##### Joint Meeting of the RID Committee of Experts and the Working Party on the Transport of Dangerous Goods

### Report of the informal working group on additive devices on tanks

Transmitted by the European Conference of Fuel Distributors (ECFD)<sup>1,2</sup>

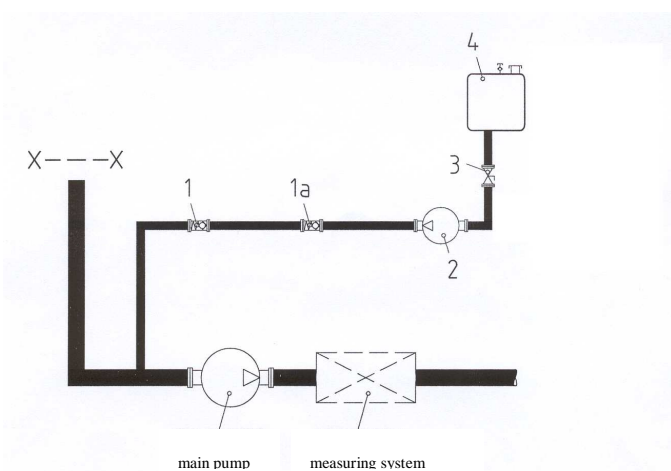
3. To start the discussion, the representative of ECFD gave a brief outline of the additive device systems currently used on tanks for the carriage of UN 1202 HEATING OIL, LIGHT, using the example of vehicles approved in Germany. Additive devices on tanks can be shown in the form of a diagram as follows:

1. Non return valve
  - 1a. Non return valve, only if a non self-closing pump is fitted
2. Additive pump
3. Shut-off valve
4. Additive container
